Georgetown Charter Township

Planning Commission Meeting Agenda

6.I. Site Plan (Revision) – (ST1615) Advanced Interiors – 6656 Pine Ridge Ct.

(ST1615) Advanced Interiors, 6656 Pine Ridge Ct., is requesting approval of a revision to an approved site plan to allow a dumpster to be located in a truck well with no screening, on a parcel of land described as P.P. # 70-14-22-477-004, located at 6656 Pine Ridge Ct., in an (I) Industrial district, Georgetown Township, Ottawa County.

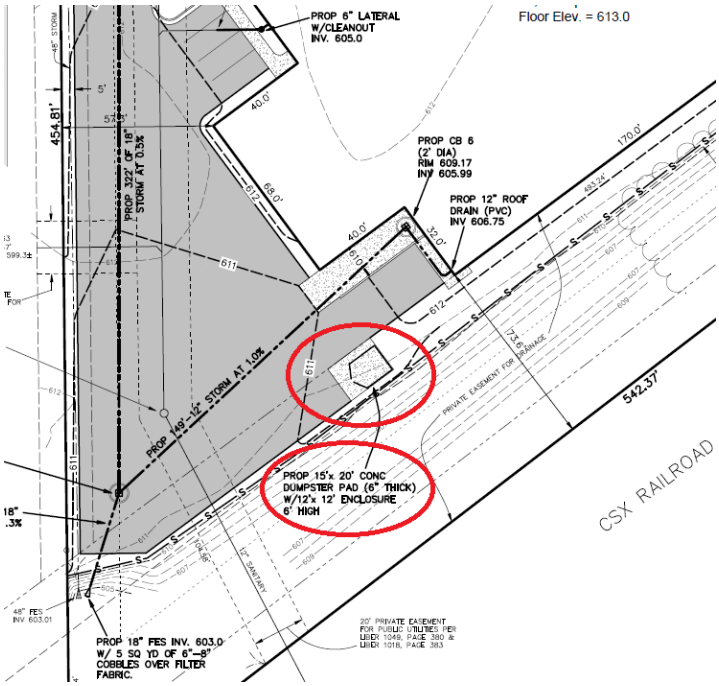
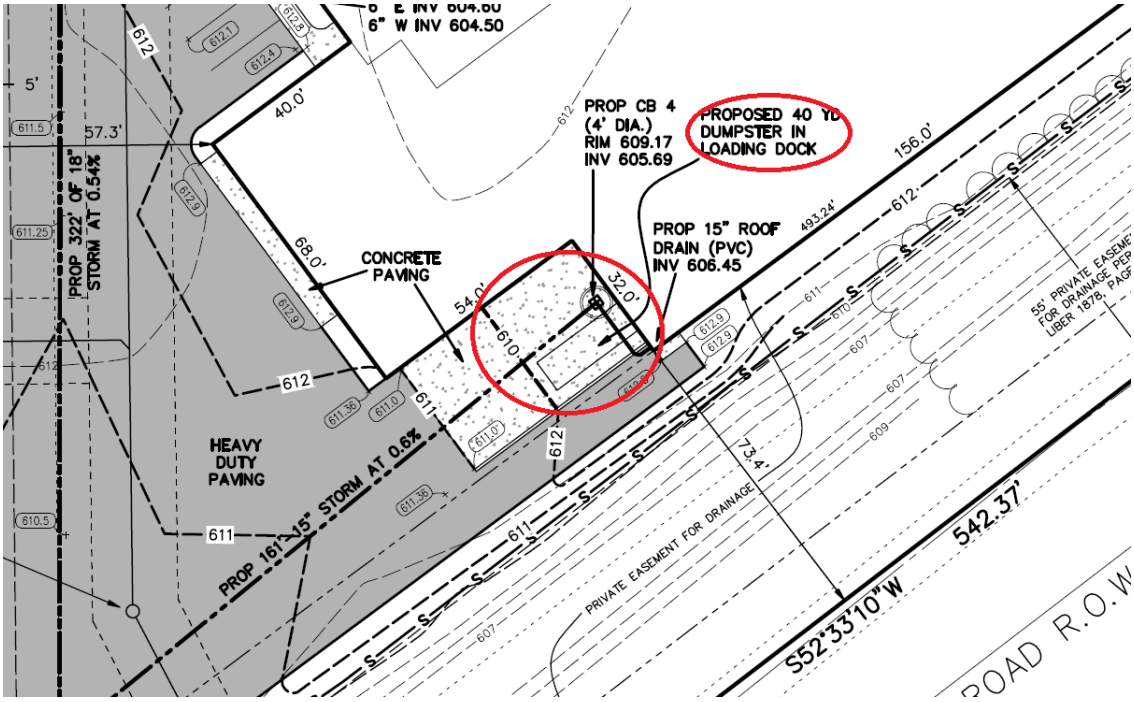
At the November 5, 2014 meeting, the Planning Commission approved a special use permit and site plan showing the dumpster to be located on a cement pad and enclosed with a six foot high fence.

The request is to locate the dumpster in the truck well and to have no screening.

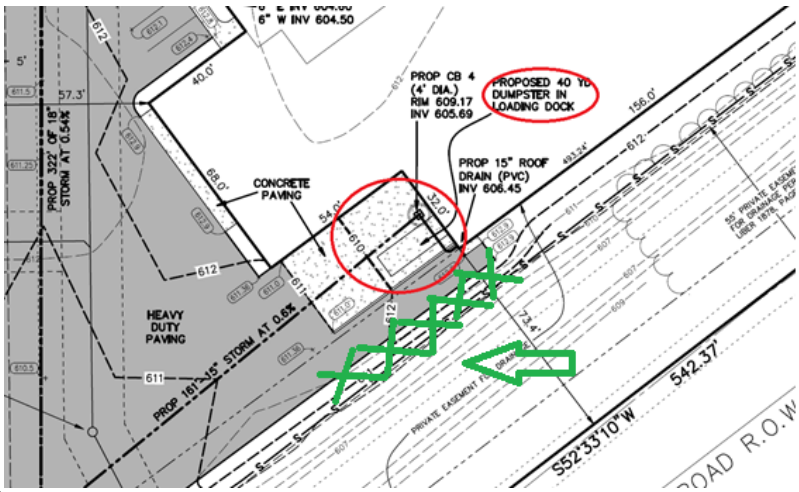
Although the Zoning Ordinance gives the Zoning Administrator the authority to approve site plans and to approve minor changes, the determination was made that this change should return to the Planning Commission since the Planning Commission initially approved the site plan that was part of the Special Use Application. Further, the approved the site plan with the dumpster on a cement pad and with screening, was based on the language in the ordinance. Therefore, the Planning Commission should determine if the new location is appropriate and if it should be allowed with no screening.

The Zoning Administrator offered to approve the new location with screening (either six foot high fencing or landscaping) to be added along the outside of the lane as shown in the drawing above. However, the applicant stated that the area is not visible from Chicago Dr. due to a berm that is covered with weeds that screens the site and is, therefore, requesting no screening.

1. Is the location of the dumpster acceptable in the truck well?
2. If yes, should the area be screened (on the Chicago Dr. side of the interior lane) with either six foot high fencing or landscaping?

SIGHT-LINE CROSS SECTION

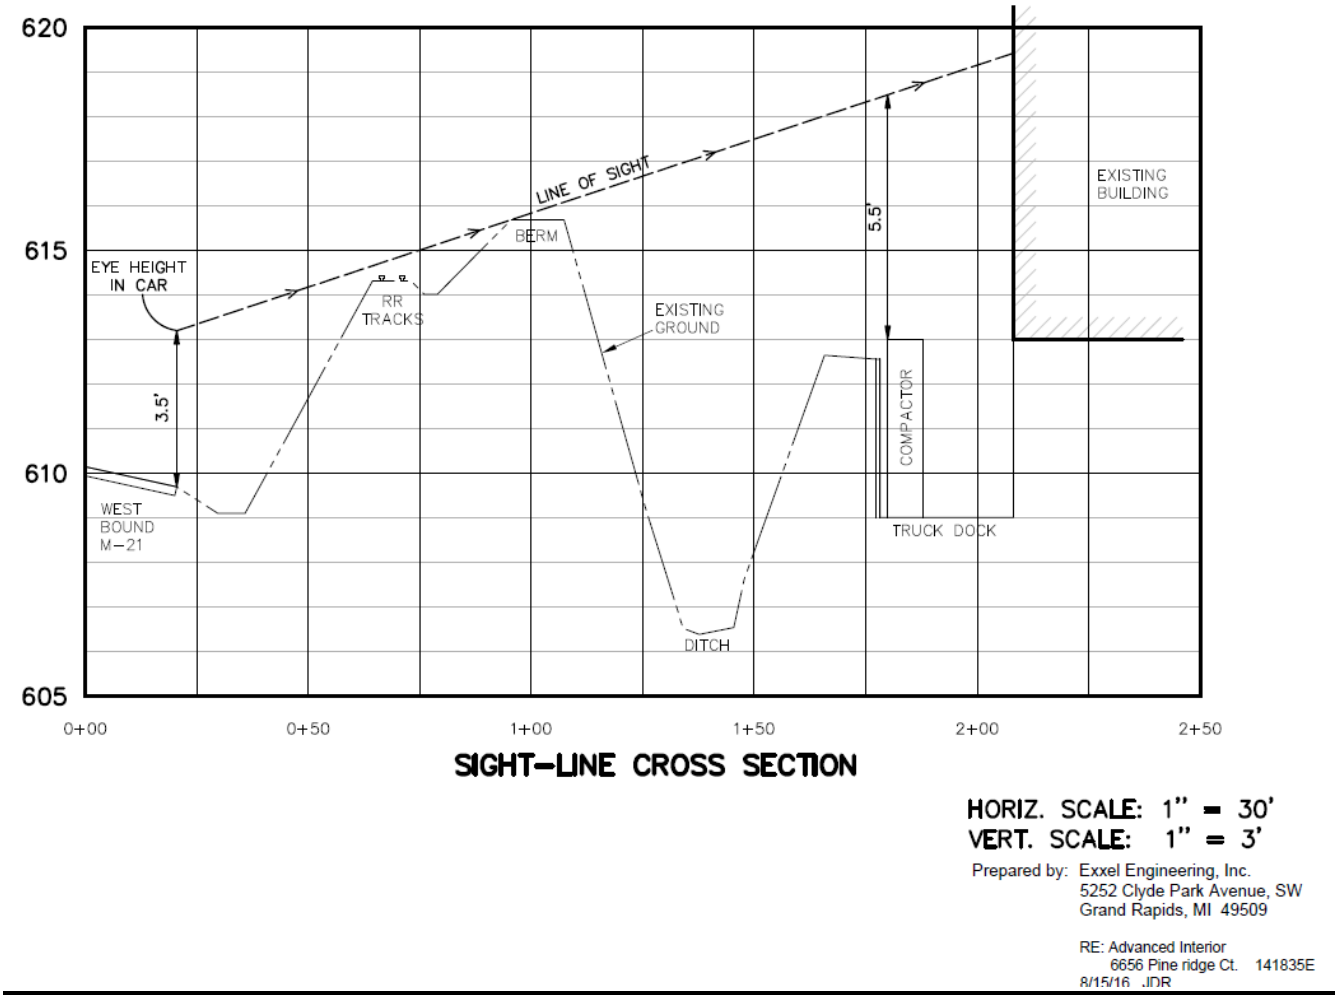
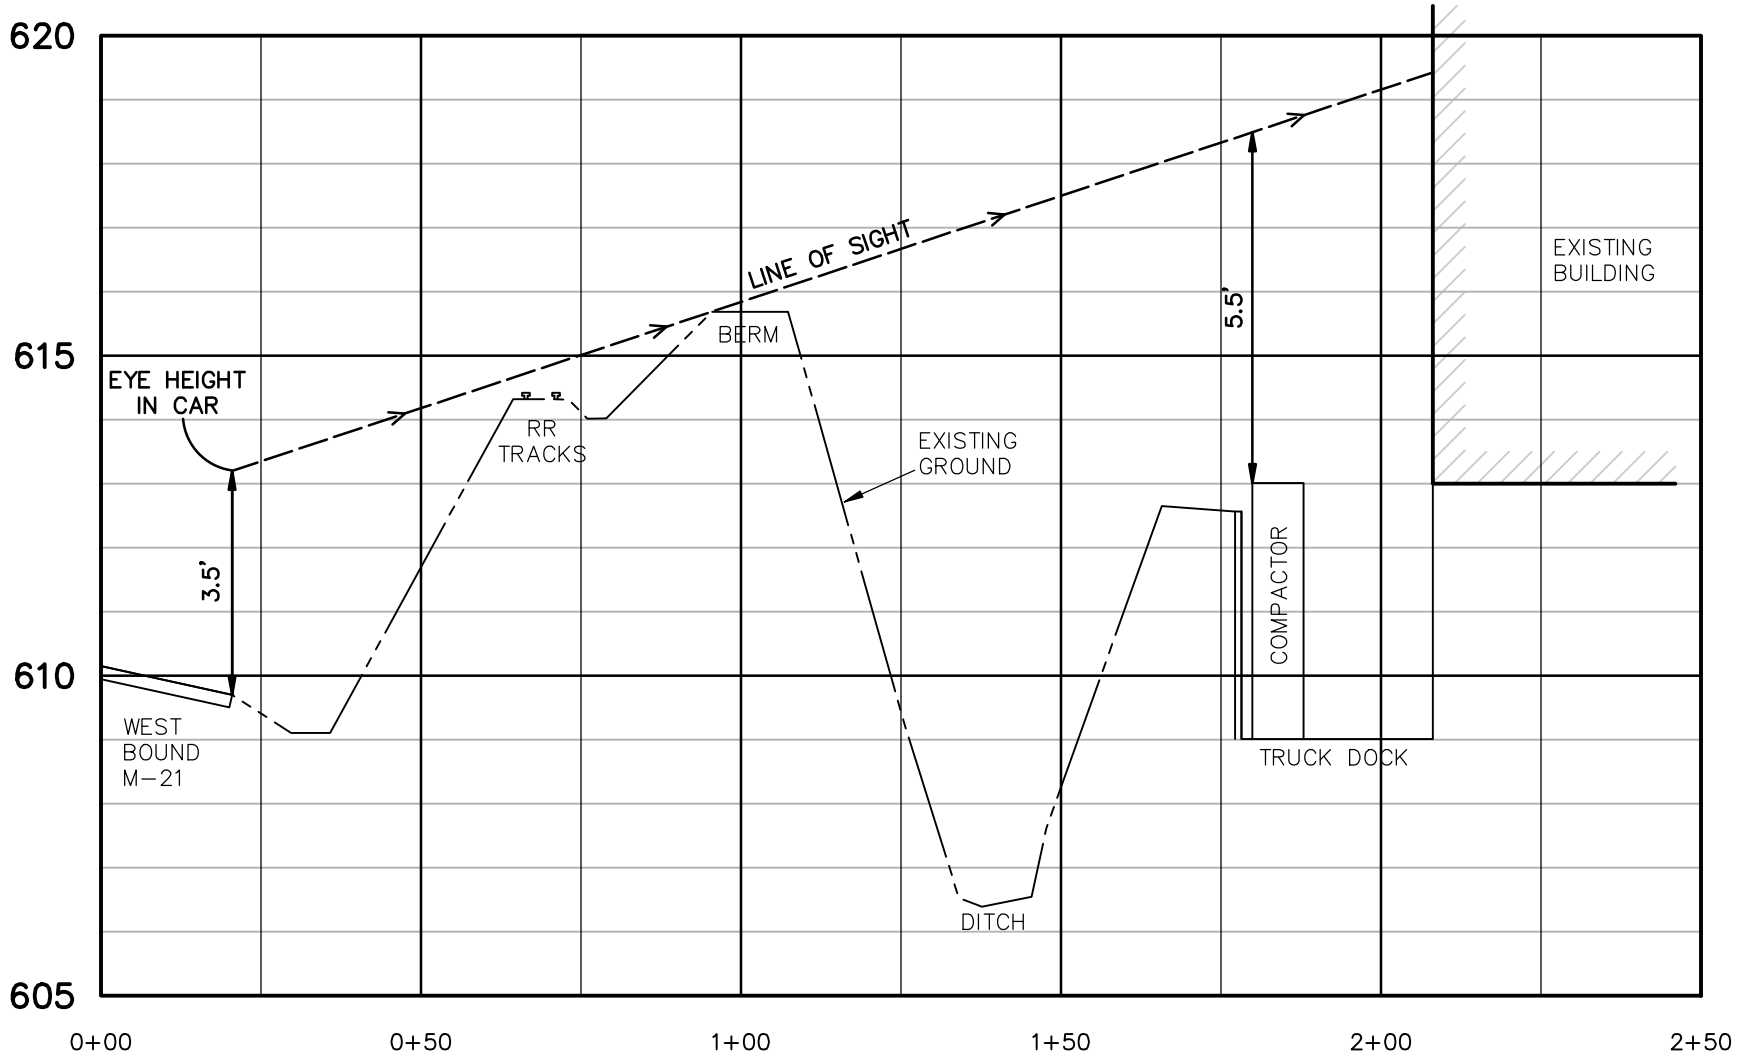
Below is the line of sight submitted by the applicant.

The concern of Code Enforcement is that they are requesting no screening and using the natural berm along with the weeds that grow on it as the screening. This area does have excessive weed growth along with other plants and flowers along a water way. The excessive weed growth and grass over 10" is a violation of our ordinance 62-27. The use of the grass and weeds as screening could be affected if enforcement of our code was necessary due to a complaint, change in enforcement philosophy or they become a negative effect on the waterway.
